# HARTING Product Change Notification

**PCN/15/009/C+N**

**Product range:** Han / Han D / DD; Han HsB; Han K

**Title:** Laser printing on several Han connector series (neu) - External

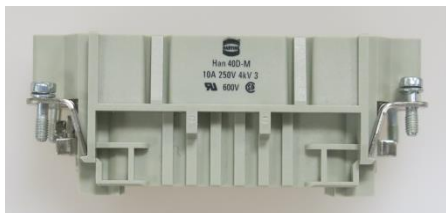
1. Han D connector inserts incl. all variants
2. Han DD connector inserts incl. all variants
3. Han HsB connector inserts incl. all variants
4. Han K 4/0 and 4/2 connector inserts incl. all variants

We like to inform you about a minor change of the product printing from pad to laser printing.

None, 100 % compatibility with the old design
